May 11, 2011
J0022-01-01

Re: Notice of Intent (NOI)
Town of Acton
Caouette Property – 2 Stow Street
Acton, MA
Supplementary Notice of Intent Data Filing

SOIL REMOVAL AREAS

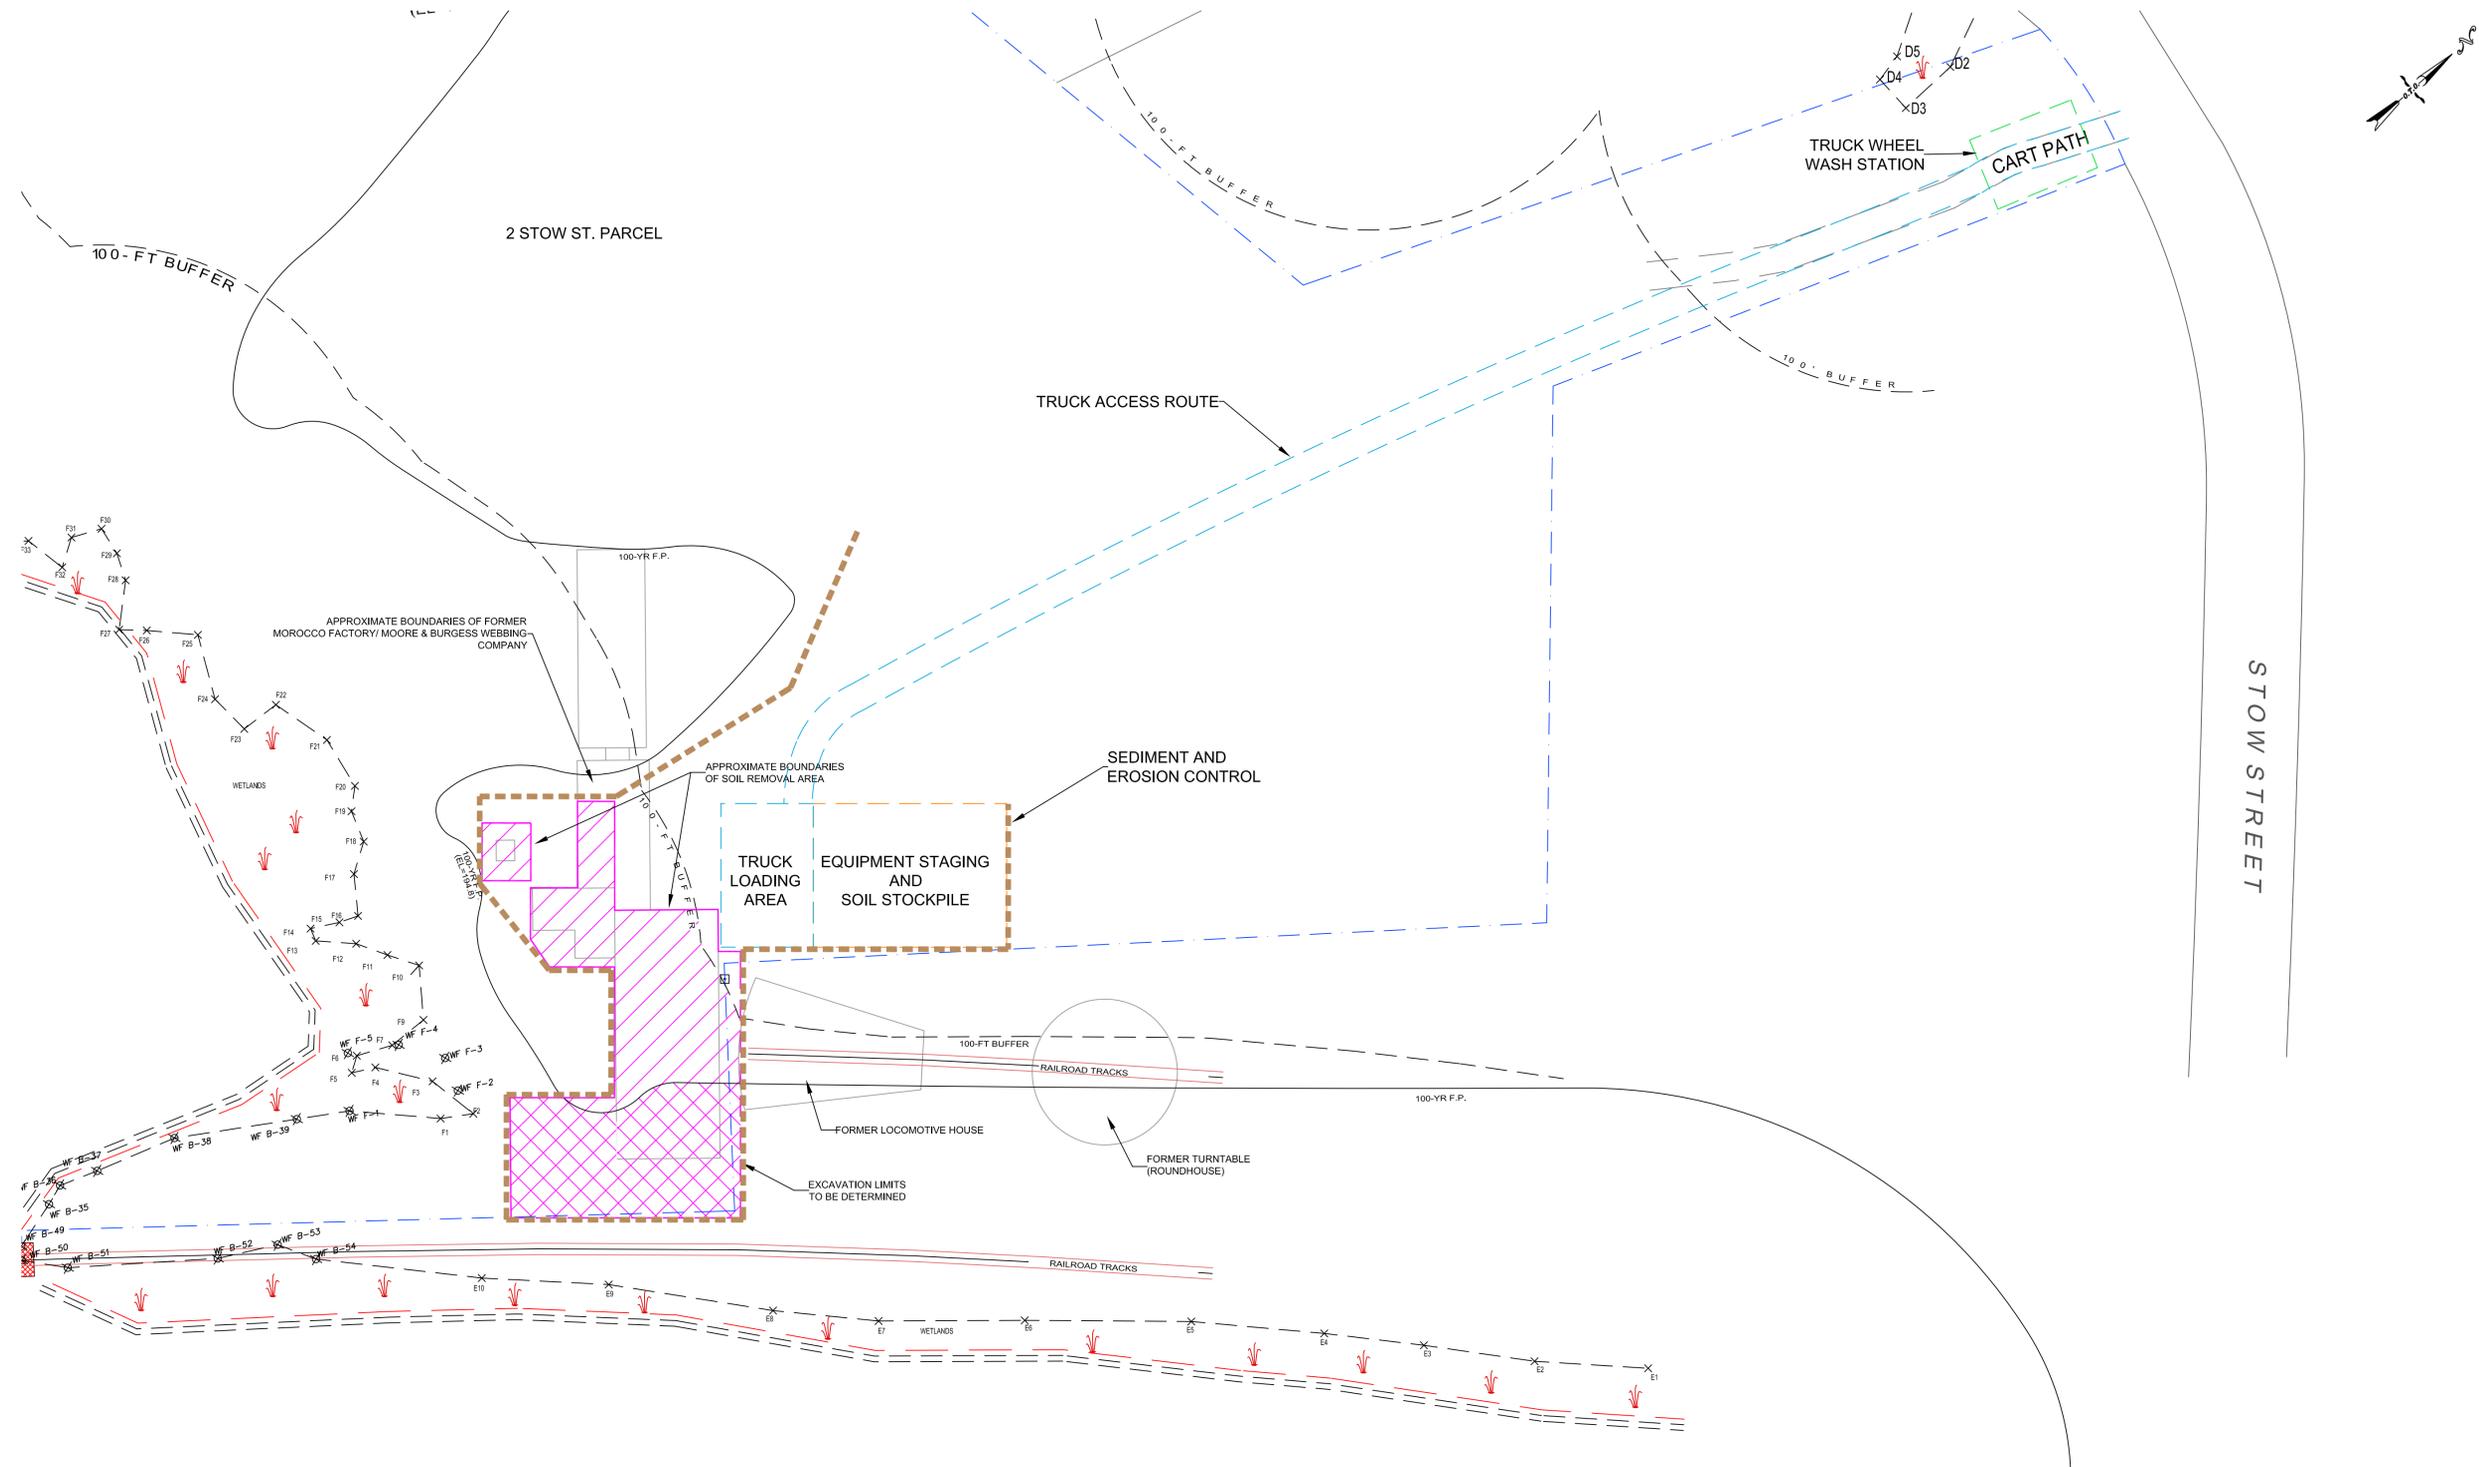
ConCom Comment No. 2. Provide a narrative description of the construction sequence and delineate the Limits of Work on the Soil Removal Areas Plan.

ConCom Comment No. 3. Identify truck travel route with a description of anticipated number of trips.

ConCom Comment No. 4. Show the location of the truck wheel wash station on the Soil Removal Areas Plan (out of the buffer zone) and provide a narrative description.

ConCom Comment No. 5. Show location of sediment and erosion control devices on Soil Removal Areas Plan and describe in narrative.

ConCom Comment No. 6. Show equipment staging area on Soil Removal Areas Plan (out of buffer zone) and describe in narrative.

ConCom Comment No. 7. Review extent of planned excavation in area of Wetland Flag F-2. If consistent with remedial objectives, revise extent of excavation to eliminate excavation in the wetlands. Show any change on the plan and describe the change in the narrative.

ConCom Comment No. 8. Show location of a possible soil stockpile (outside of buffer zone) on the Soil Removal Areas Plan. Provide a narrative description of the soil stockpile management.

The Limits of the Work area are shown on the Soil Removal Areas Plan. We anticipate that the construction sequence will be as follows:

The truck travel route is shown on the Soil Removal Areas Plan. An estimated total of approximately 614 cubic yards of impacted soils to be excavated were initially identified at the

The proposed truck wheel wash station location (out of the buffer zone) has been added to the Soil Removal Areas Plan.

The sediment and erosion control devices have been added to the Soil Removal Areas Plan.

The equipment staging area (out of the buffer zone) has been added to the Soil Removal Areas Plan.

The approximate boundary of the planned excavation in the area of Wetland Flag F-2 has been reviewed, and has been revised accordingly as depicted on the Soil Removal Areas Plan.

The possible soil stockpile location (out of the buffer zone) has been added to the Soil Removal Areas Plan.

DRAWING TITLE:
PLANTING PLAN

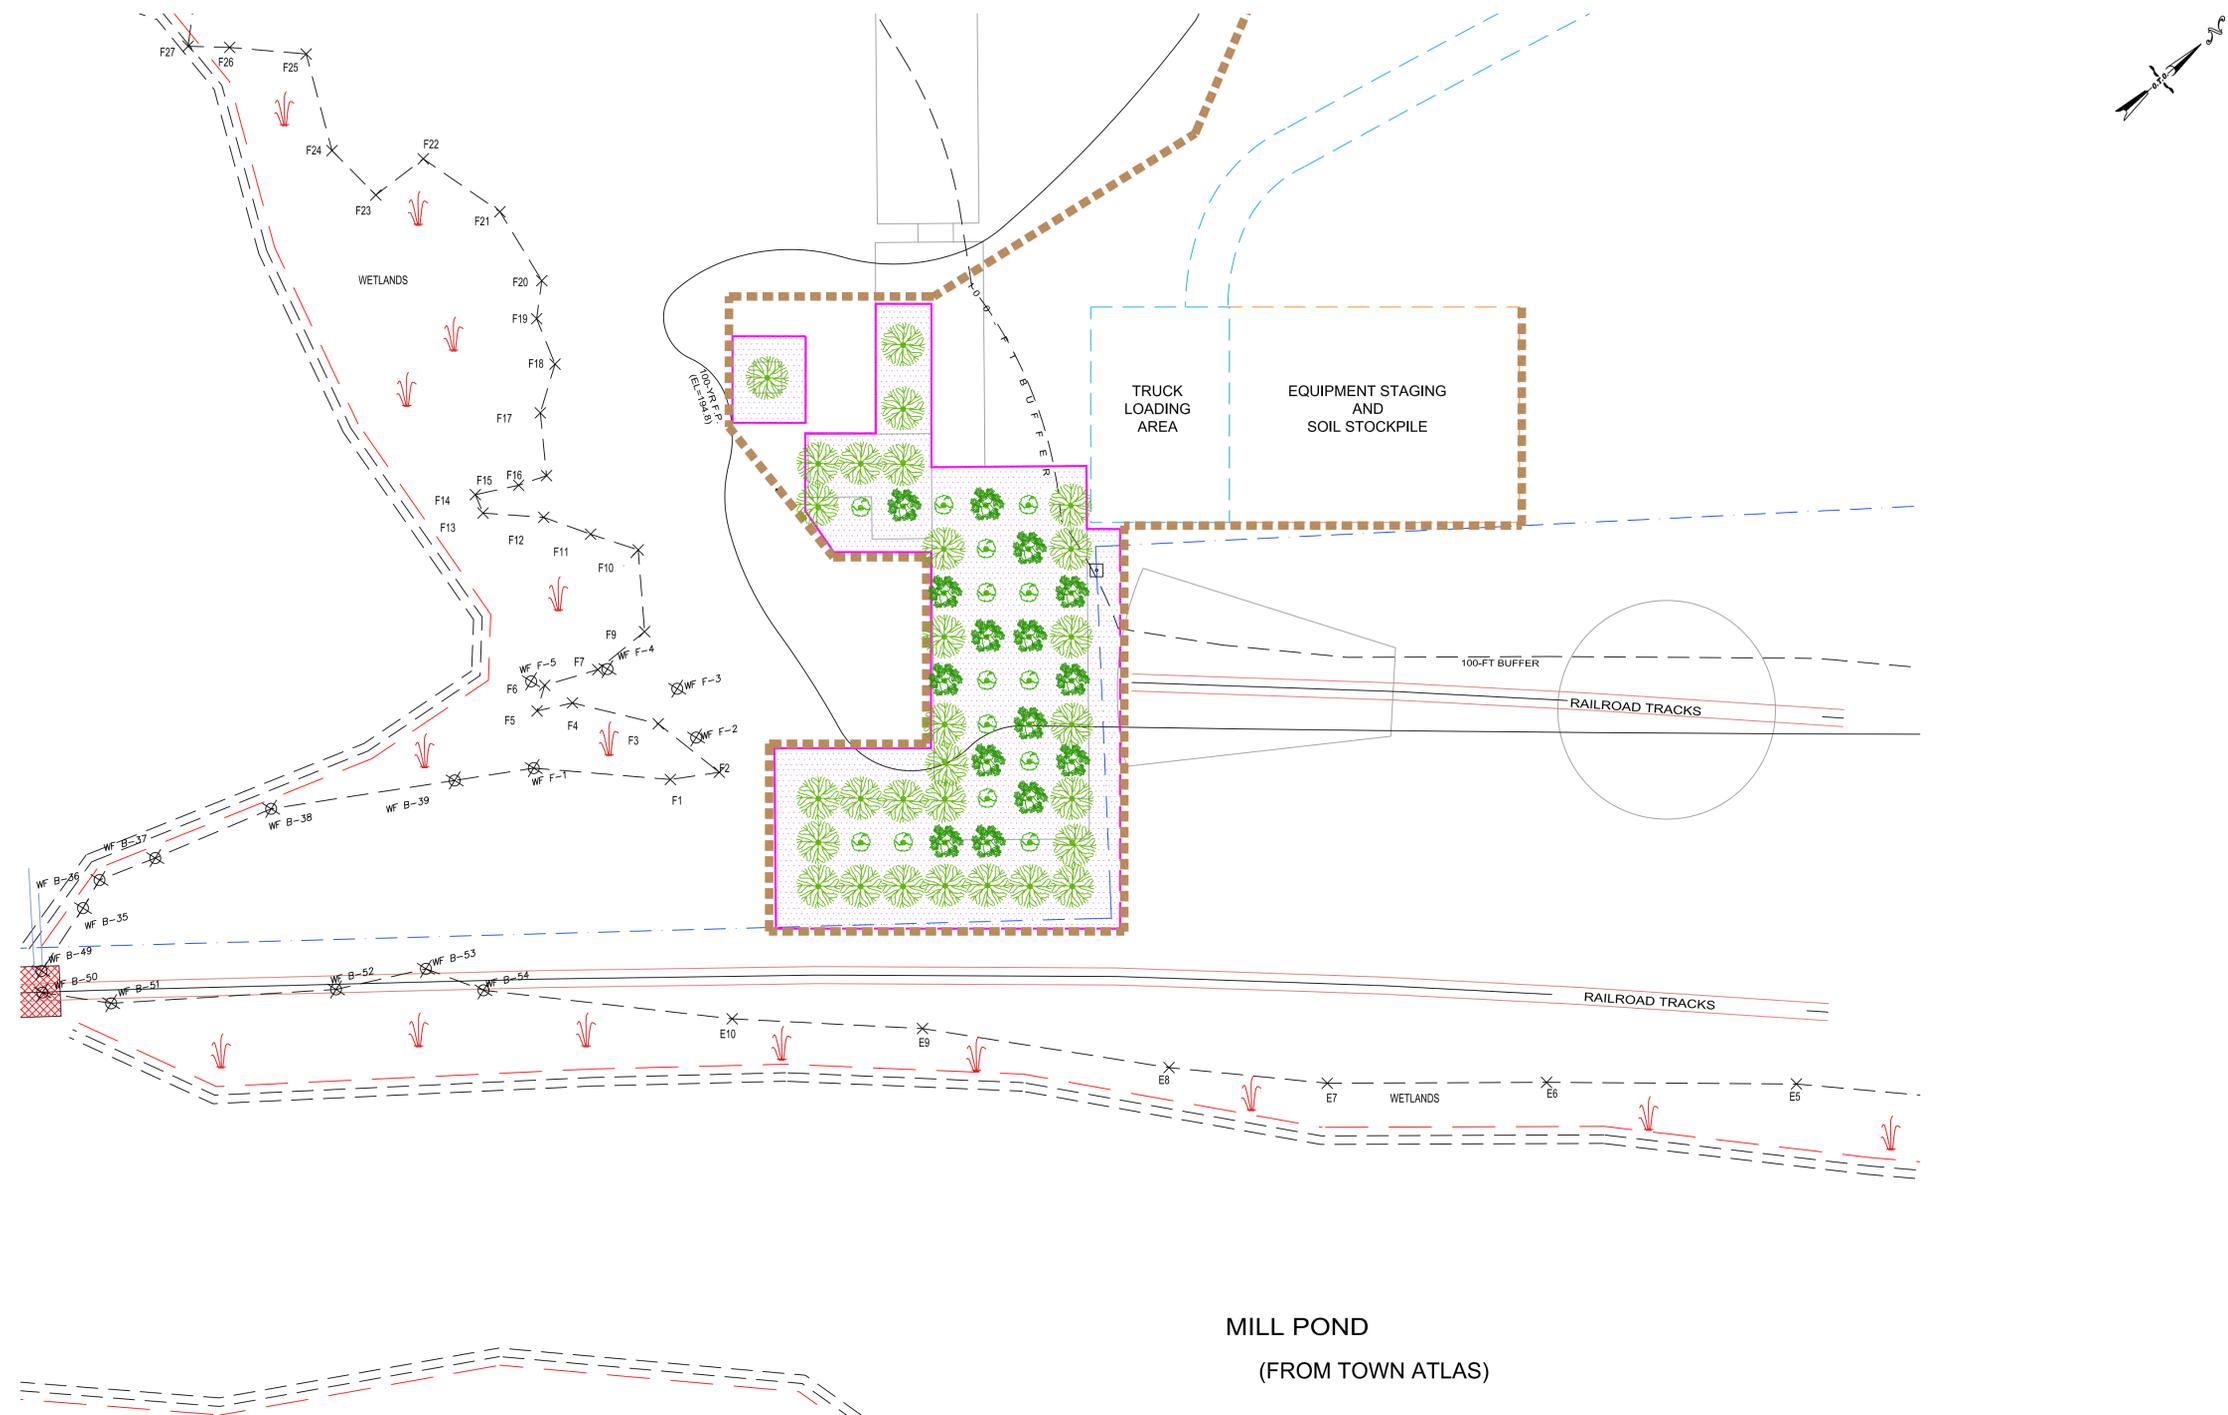
ConCom Comment No. 10. Provide a planting plan and a table summarizing the type and number of plants to be used, their height, and the planned density/spacing interval.

The planting plan showing the locations of proposed species has been attached.

In combination with the wetland seed mix, trees and shrubs will be added to the restoration plan. Tree species will include *Acer rubrum* (red maple) and shrub species will consist of *Cornus racemosa* (gray dogwood) and *Amelanchier canadensis* (serviceberry) (Table 2). Within the remediation area,

shrubs and trees will be spaced at intervals of 10 feet on center for a total of 58 individuals. It is proposed that the shrubs (3'-4') and trees (3'-4') be purchased from New England Wetland Plants (NEWP) located in Amherst, Massachusetts.
